Technical Service Bulletin: TSB120028

Fleetguard® CH44105 & CH44120 Centrifuge Retainer Change

Figure 1: Old (1) and New (2) Centrifuges Retainer Designs

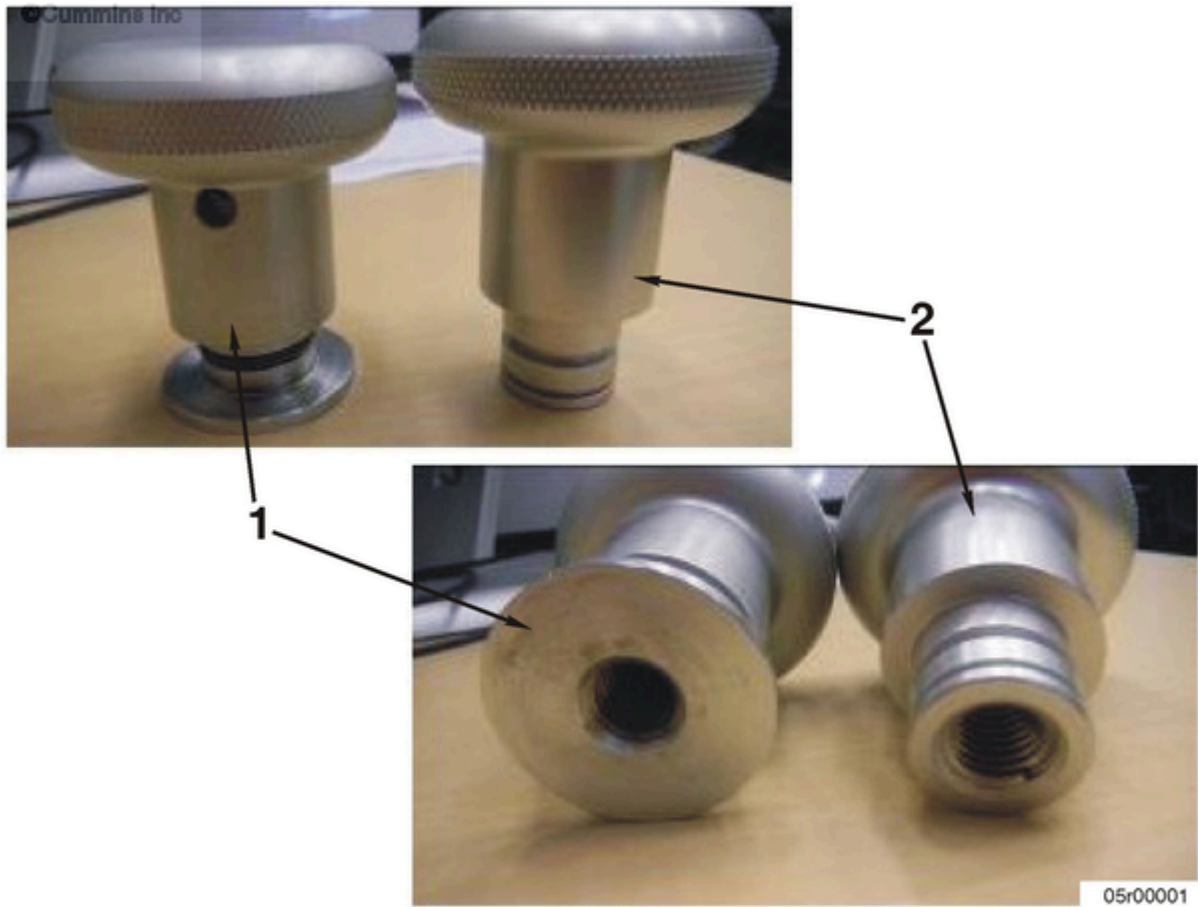
A batch of Fleetguard® CH44105 centrifuges has been produced that have out of specification top retainers. The new style retainer (#2 in Figure 1) was a cost reduction design change to the CH44105 & CH44120 products purchased by Fleetguard®. The new style retainer is out of specification in flatness and parallelism. This causes the edge of the retainer to act as a cutting tool against the bushing material on the top of the internal rotor shaft, causing the bushing to malfunction. Additionally, the smaller outside diameter (OD) of the retainer has an increased load per unit area (#2 in Figure 2).

This has been corrected by Fleetguard® by reverting all centrifuges in stock back to the older style retainer. In Plant the engine serial number (ESN) first for engines built with known good centrifuges is 33189155, built 12 September 2011.

Figure 2: Cut-Away Views of Old (1) and New (2) Centrifuge Retainer Designs.

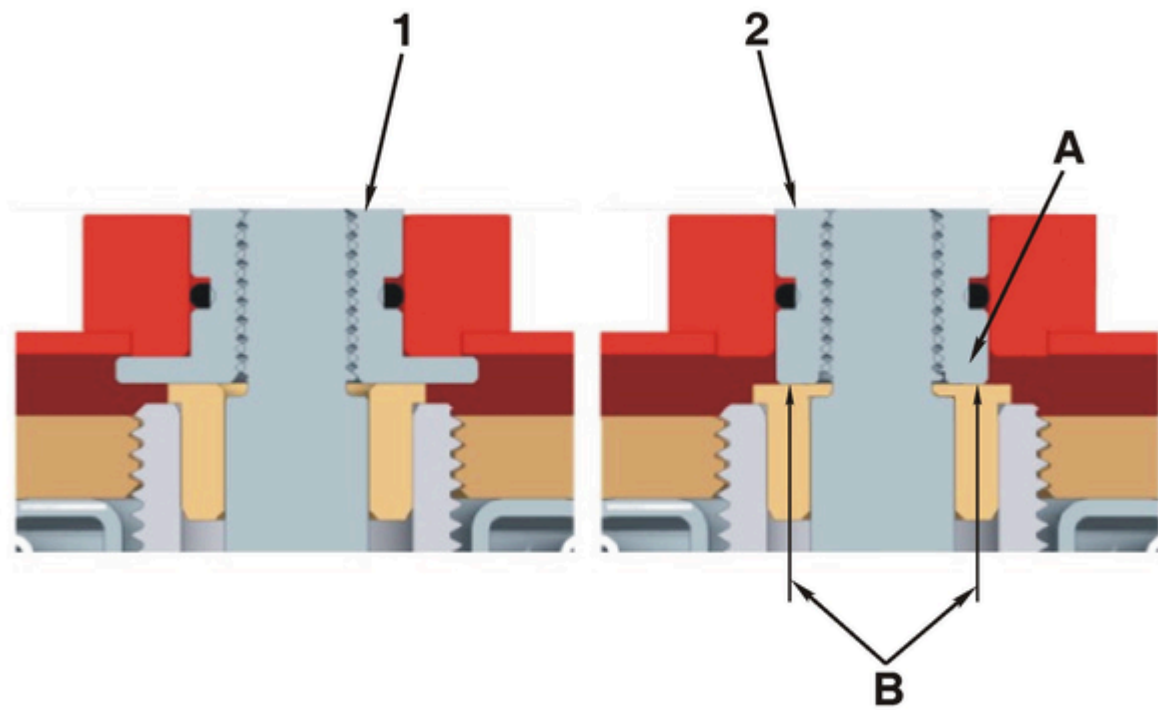
(A) New knob design **not** fully utilizing bearing surface area.

(B) Location of the bushing wear.
